Work Order ID 120987

Item Name: Doubler

ENGINEERING CHANGE NOTICE NL 04510

DWG NO. 647.4100

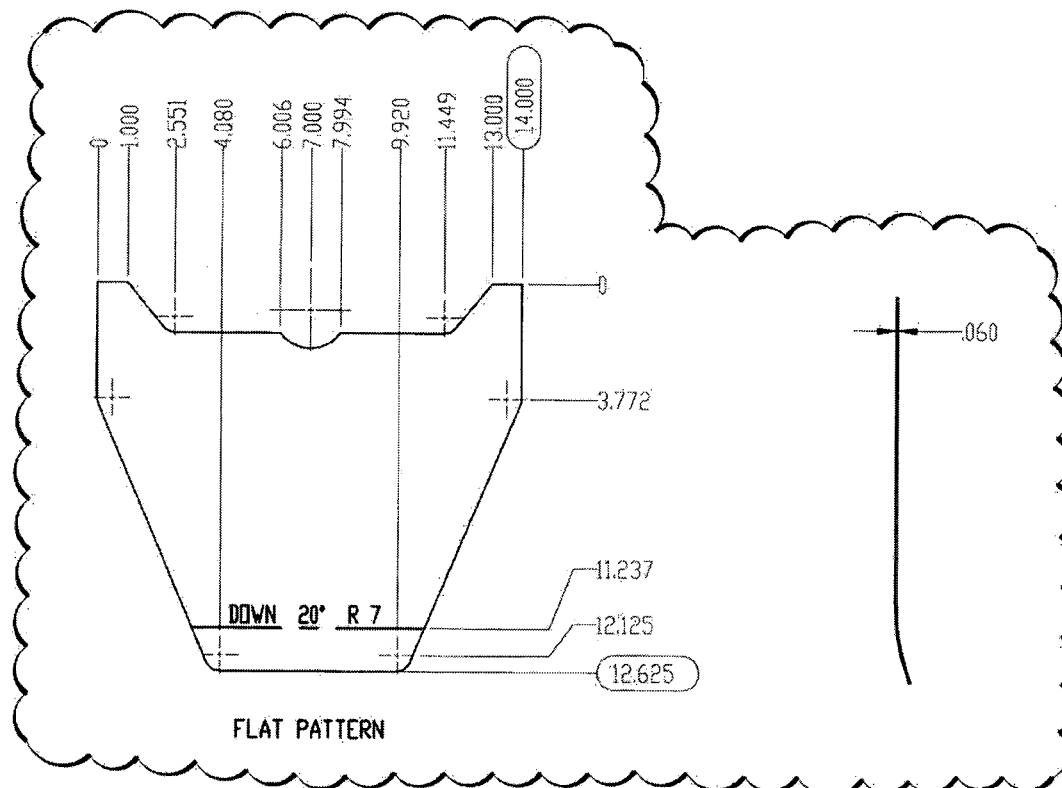
REASON: MODIFIED DOUBLER.

FLAT PATTERN

SHEET 1, ZONE C2 IS:

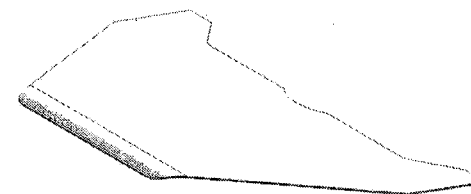
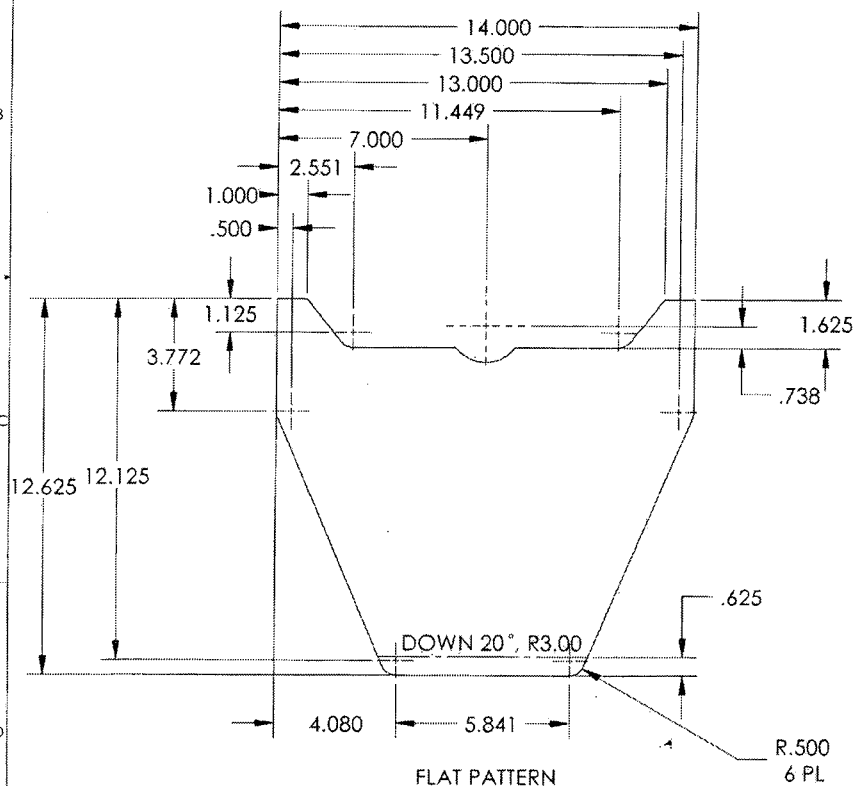
APICAL INDUSTRIES, INC.	ENGINEERING CHANGE NOTICE NO. 02866				SHEET 1 OF 1	
	DWG NO. 647.4100	REV: N/C	PREPARED BY R. ROSANO	DATE: 05/05/10	EFFECT ON DWG <input type="checkbox"/> INC. <input checked="" type="checkbox"/> UNINC.	
	DWG TITLE: SHEET METAL					
	APPROVED BY: ENGR <i>[Signature]</i>	MFG <i>[Signature]</i>	QC <i>[Signature]</i>	EFF: CURRENT ORDER		
TRANSACTION CODES (TC): A-ADD C-CREATE R-REVISE D-DELETE		REASON: CHANGED PRETREATMENT CALLOUT

SHEET 1, ZONE A1 IS:

2. FINISH: HARD ANODIZE IAW MIL-A-8625 TYPE II,
CLASS 2, COLOR BLACK;
PRETREAT PR-148 ADHESION PROMOTER
PRIME IAW MIL-P-23377J TYPE I CLASS N

- 1 MATERIAL: ALUMINUM 2024-T3 PER AMS-QQ-A-250/4
- 2 FINISH: HARD ANODIZE IAW MIL-A-8625 TYPE II, CLASS 2, COLOR BLACK;
CARDINAL 4860-50 PRETREATMENT PRIMER
PRIME IAW MIL-P-23377J TYPE I CLASS N
- 3 DEBURR AND BREAK ALL SHARP EDGES
- 4 IDENTIFY IAW MPP-120
